WORKING DRAFT OF NEC CODE-MAKING **PANEL 12 MEETING OUTPUT**

Document: National Electrical Code®

Revision Cycle: A2025

Meeting Date: October 2024

Figure Informational Note 620.62 Selective Coordination for Overcurrent Protective Devices Supplying More Than One Elevator.

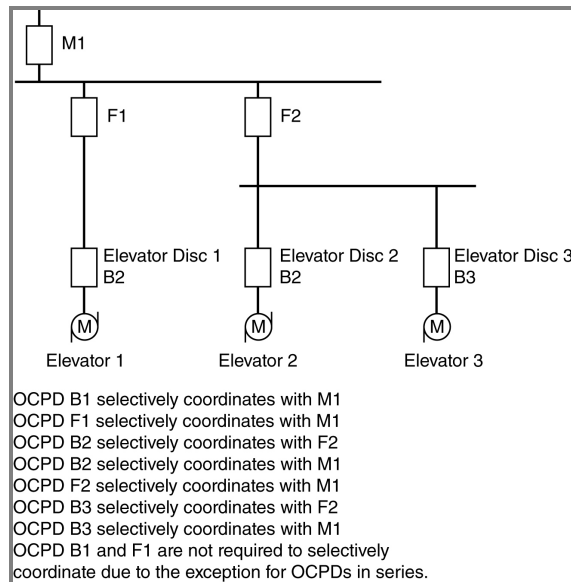
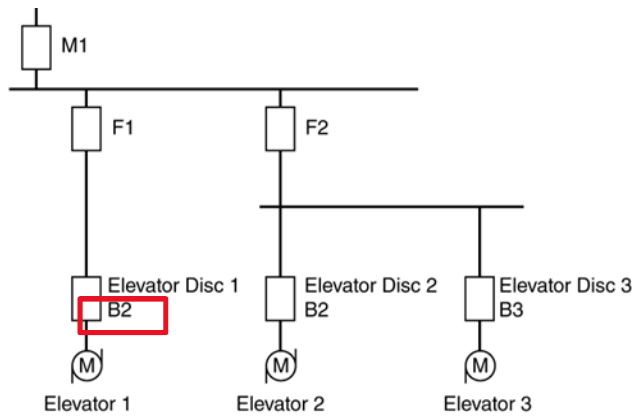
Informational Note: See Figure Informational Note 620.62 for an example of how OCPDs supplying elevators selectively coordinate with all supply-side OCPDs.

<u>File Name</u>	<u>Description</u>	<u>Approved</u>
Corrected_Figure_for_620.62_C_.docx	Figure showing where to correct the existing B2 under Elevator Disc 1 to B1 for Figure Informational Note 620.62 Selective Coordination for Overcurrent Protective Devices Supplying More Than One Elevator.

THE FIGURE NEEDS TO BE UPDATED/CORRECTED BY CHANGING THE CIRCLED “B2” TO “B1”

Committee Statement: The change to the overcurrent device terminology is for consistency throughout the code. The revision to the figure corrects an error in the figure as the B2 under Elevator Disc 1 in the figure should be B1.
